Access Compliance Report

Public Rights-of-Way

(Curb Ramps)

Intersection ID: 43227	Main Street: N I-77_EXIT_5_RA	Cross Street: N I-77_HY	Location: S
ADA ID: 5C0A22623ED8	Ramp Type: BlendTrans1	Initial Pass/Fail: Fail	Overall Compliance: No
			Severity Score: 16.25

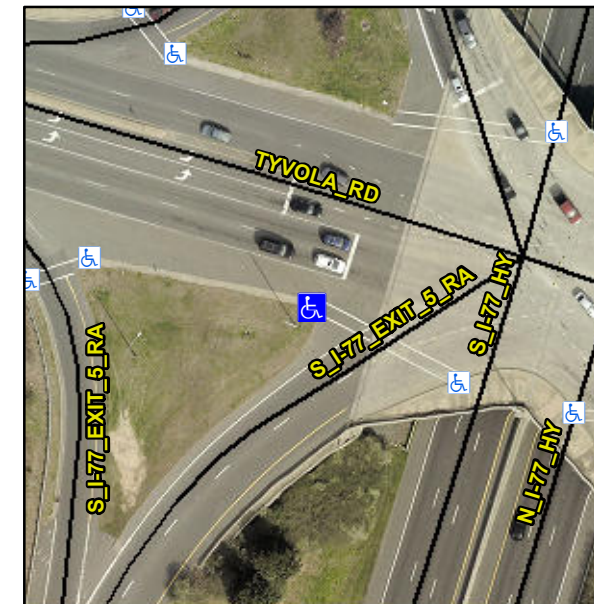
R302.7

Compliance	Description	Data	Compliance	Description	Data
N/A	Ramp Length (in)	56.0	Yes	BlendTrans Slope (%)	0.7
Yes	Ramp Width (in)	60.0	Yes	BlendTrans XSlope (%)	2.7
N/A	Flare Type LT	N/A	N/A	Flare Type RT	N/A
N/A	Flare Slope LT (%)	N/A	N/A	Flare Slope RT (%)	N/A
N/A	Flare Traversable LT?	N/A	N/A	Flare Traversable RT?	N/A
N/A	Landing Length (in)	N/A	N/A	DWS Provided?	N/A
N/A	Landing Width (in)	N/A	N/A	DWS Contrast?	N/A
N/A	Landing Slope (%)	N/A	N/A	DWS Length (in)	N/A
N/A	Landing X Slope (%)	N/A	N/A	DWS Full Width?	N/A
N/A	Landing Curb? (Y/N)	N/A	N/A	DWS Offset (in)	N/A
N/A	Shared Landing?	N/A			
N/A	Gutter Ponding?	N/A	N/A	Gutter Slope (%)	N/A
N/A	Gutter Lip Ht (in)	N/A	N/A	Gutter X Slope (%)	N/A
N/A	Painted X Walk1?	Yes	N/A	Painted X Walk2?	N/A
	X Walk 1 Direction	To SE		X Walk 2 Direction	N/A
	X Walk 1 Width (in)	73.5		X Walk 2 Width (in)	N/A
	X Walk 1 Slope (%)	4.4		X Walk 2 Slope (%)	N/A
	X Walk 1 X Slope (%)	5.7		X Walk 2 X Slope (%)	N/A

N/A	Ramp inside XWalk1?	Yes	N/A	Ramp inside XWalk2?	N/A
	Road Slope (%)	5.7		Clear Space?	N/A
	Road X Slope (%)	4.4	N/A	Clear Space to XWalk (in)	N/A
N/A	Any Obstructions?	N/A	N/A	Storm Grate/Utility Hazard?	N/A
	Obstruction Type			Storm Grate/Utility Type	
		N/A			N/A
		No		Surface Condition? (G/P)	Poor
		Yes		Curb Slope (%)	2.5

Remove & Replace Curb Ramp With Two New Directional Ramps or Equivalent.
